SANITARY SEWER PLAN & PROFILE

C.401

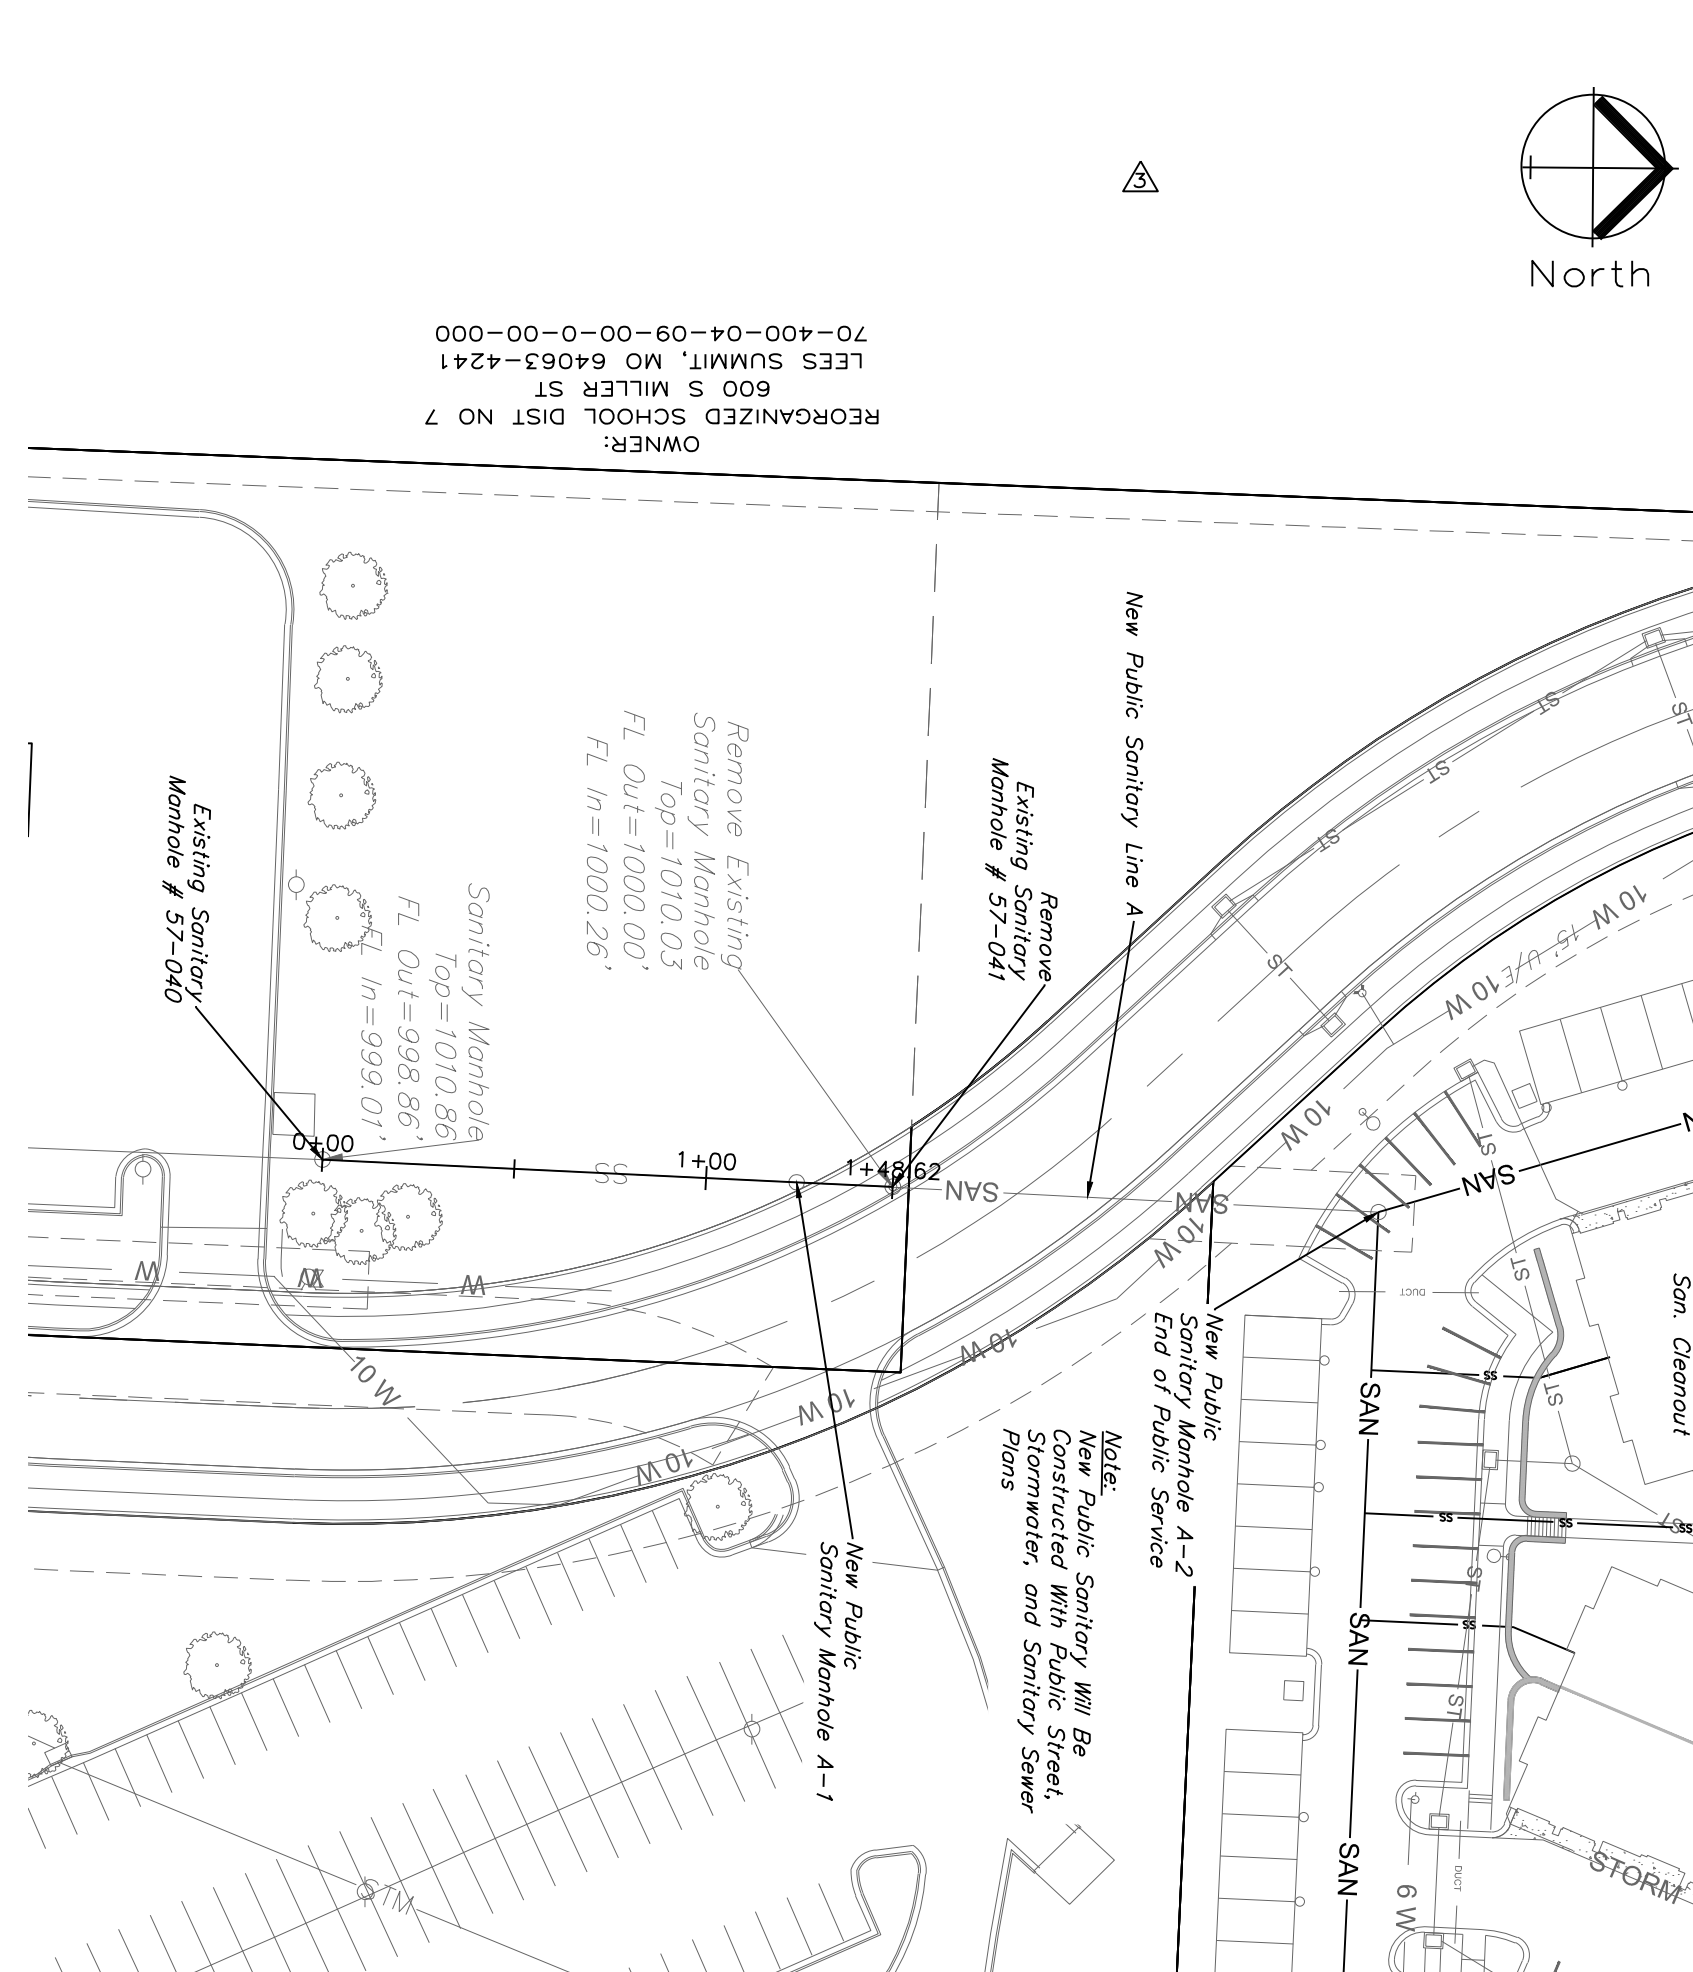
-  **REV 3-21-17**
- Planning Review
1. Relocated the monument signs to be outside the easements.
 8. Updated the building addresses as requested.
- Engineering Review
2. Labeled the sanitary and water lines as private as requested.
 14. Removed the cover sheets for the private water and sanitary.
 16. Reconciled the manholes to the correct heights.
 19. Provided the requested cleanouts for the sanitary stubs.

-  **REV. 5-3-17**
- Engineering Review
23. Provided the Off-Site Sanitary Extension with this submittal.
24. Provided a separate Plan and Profile for the Existing Sanitary Sewer.
25. Reconciled the labels for the Public and Private Sanitary Lines.
26. Added the Missing Flowline In.
30. Enlarged text size and provided legend.
